PG&E Letter DCL-03-047

Docket No. 50-275, OL-DPR-80
Docket No. 50-323, OL-DPR-82
Diablo Canyon Units 1 and 2
Response to NRC Request for Additional Information Regarding License
Amendment Request 02-03, "Spent Fuel Cask Handling"

**PG&E Response to NRC Request for Additional Information Regarding License
Amendment Request 02-03, "Spent Fuel Cask Handling"**

SAFETY ANALYSIS REPORT

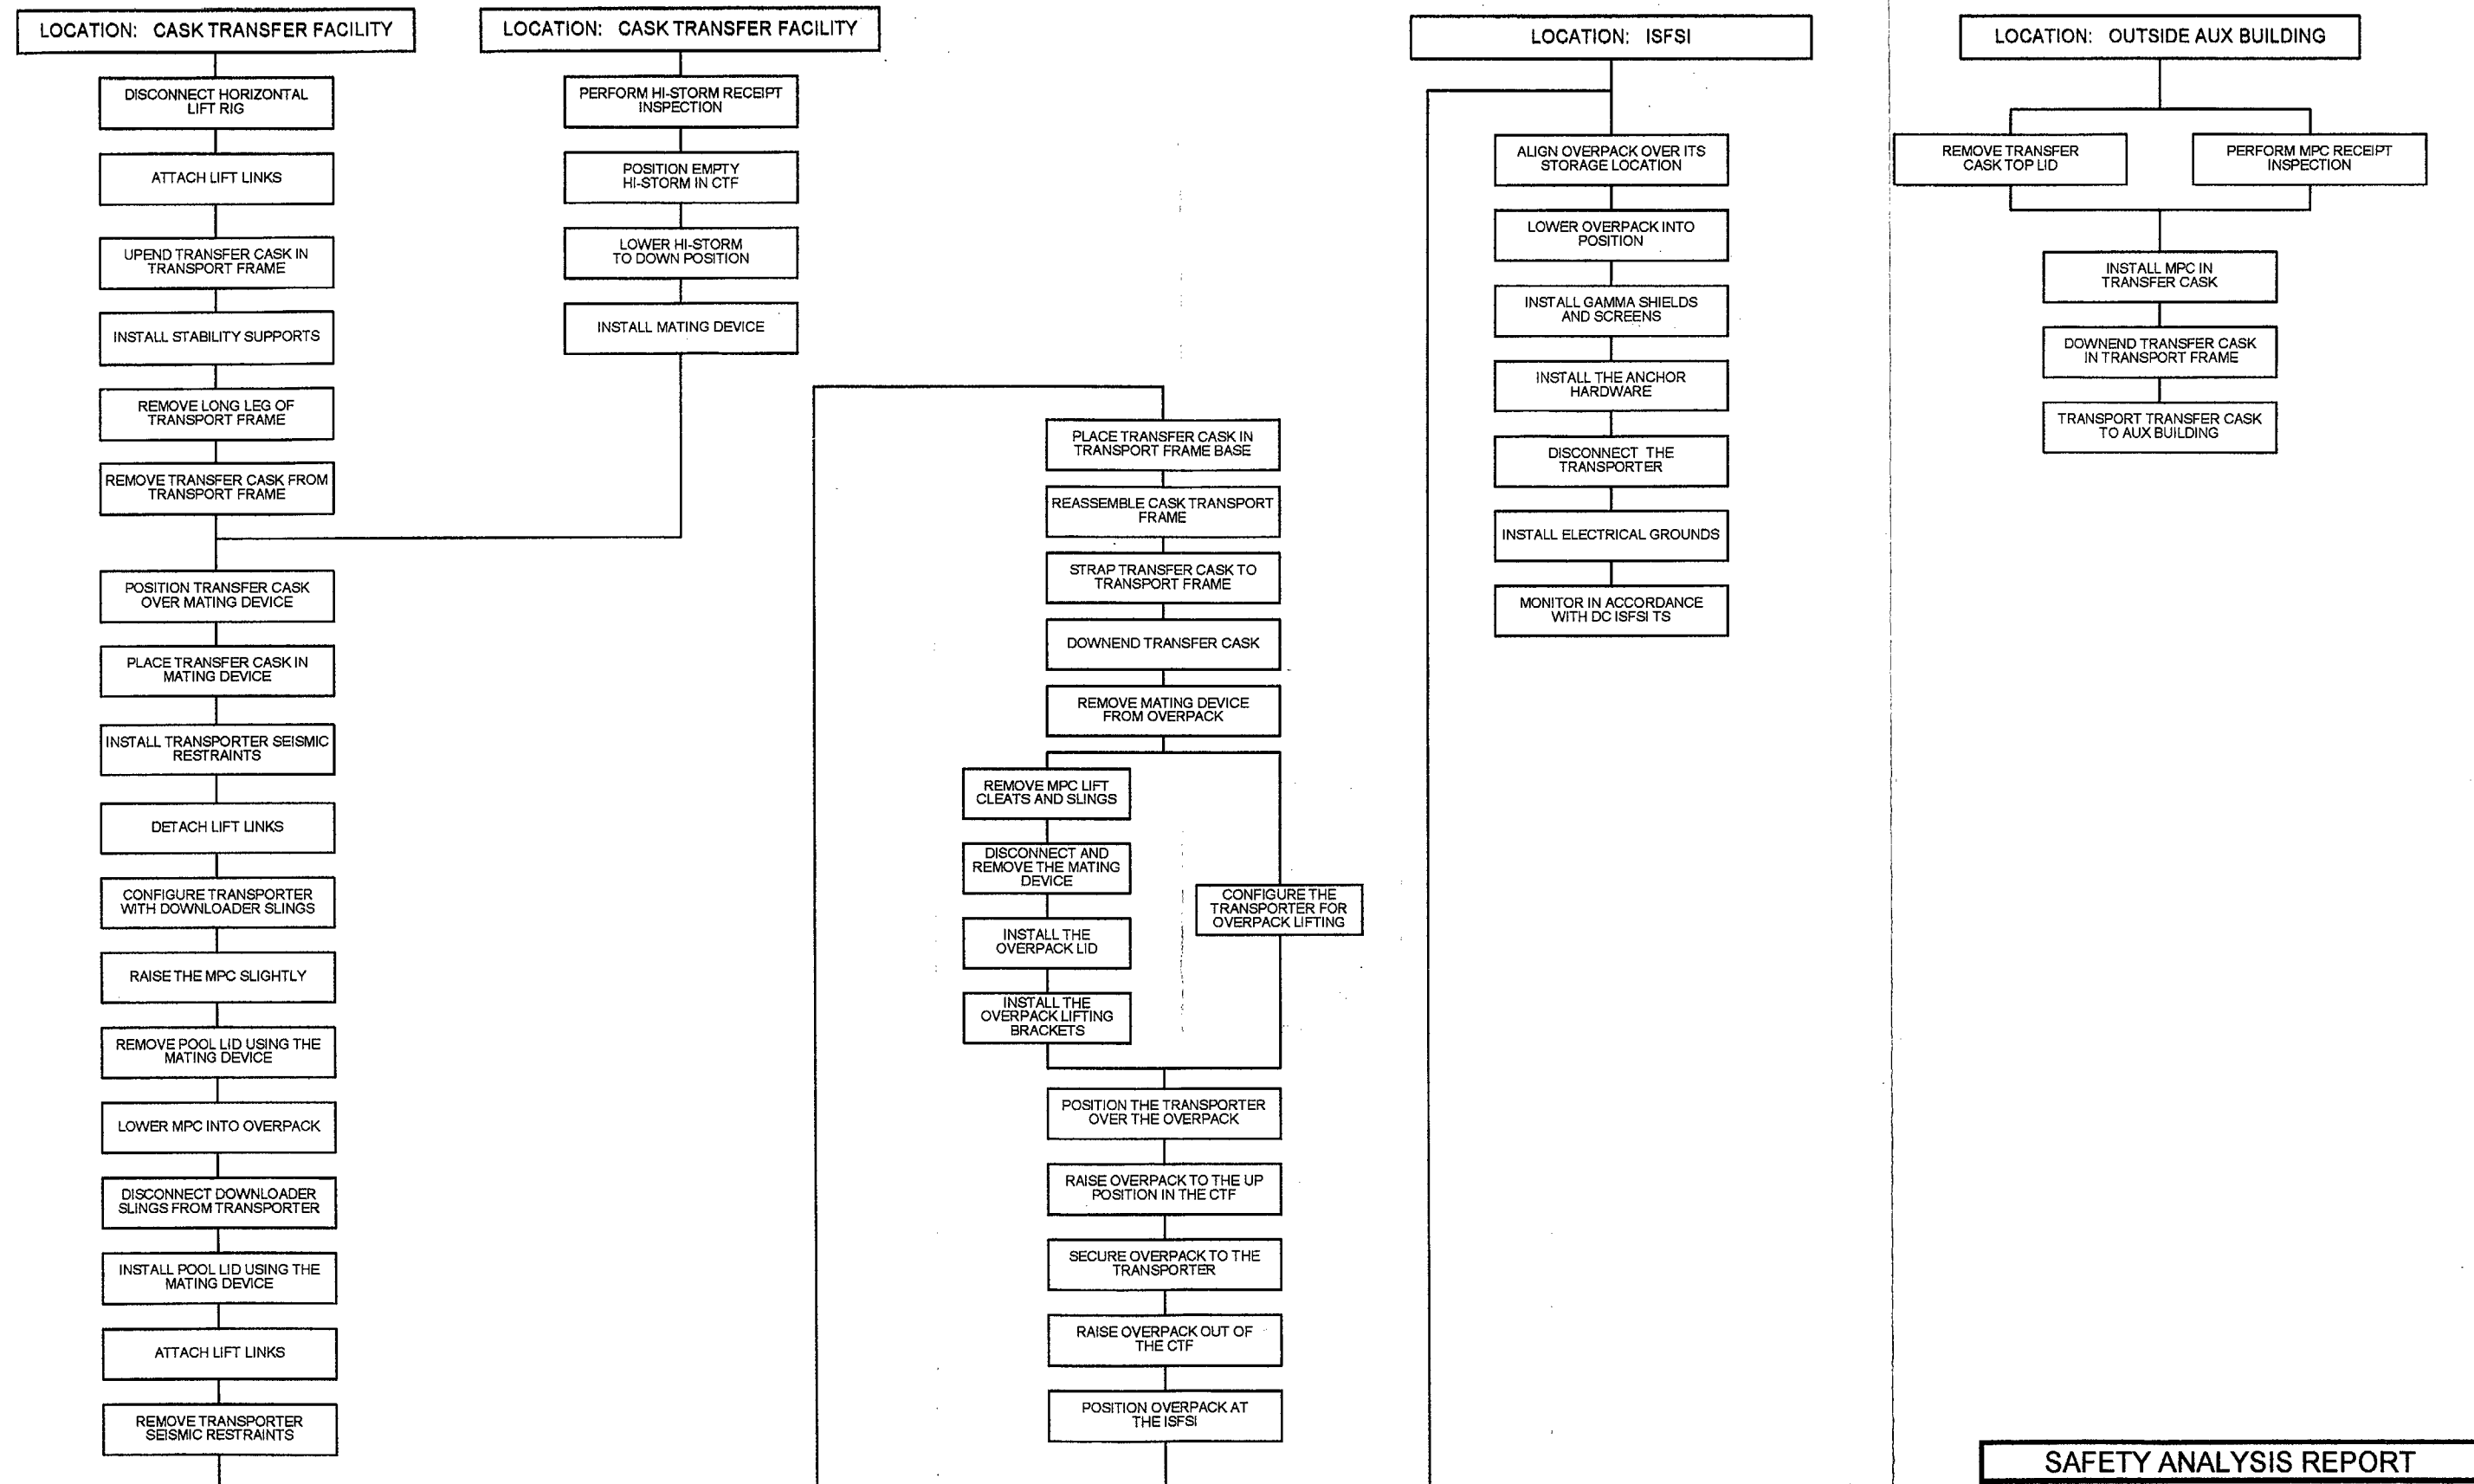
The Diablo Canyon Power Plant (DCPP) license amendment request to revise the DCPD updated final safety analysis report (UFSAR) regarding its control of heavy loads program proposes to eliminate the spent fuel cask exclusion zone. The UFSAR restricts cask movement to the portion of the spent fuel pool which is over the cask recess area. The defense-in-depth approach within NUREG-0612, "Control of Heavy Loads at Nuclear Power Plants," states that despite the increase reliability of the overhead handling system licensees should (1) provide sufficient operator training, handling system design, load handling instructions, and equipment inspection to assure

reliable operation of the handling system; and (2) define safe load paths through procedures and operator training so that to the extent practical heavy loads avoid being carried over or near irradiated fuel or safe shutdown equipment. Provide your basis for eliminating the cask exclusion area? Demonstrate how the defense-in-depth philosophy described will be maintained through your cask handling operations supporting your proposed independent spent fuel storage installation (ISFSI).

An operational sequence depicting the cask handling operations is presented in the enclosed Diablo Canyon ISFSI SAR Figure 5.1-1, which was previously submitted in PG&E Letter DIL-01-002 dated December 21, 2001 under Docket No. 72.26. Using LAR Figures 8 and 9 along with the sequence presented, provides a "pool to pad" map of cask handling operations.
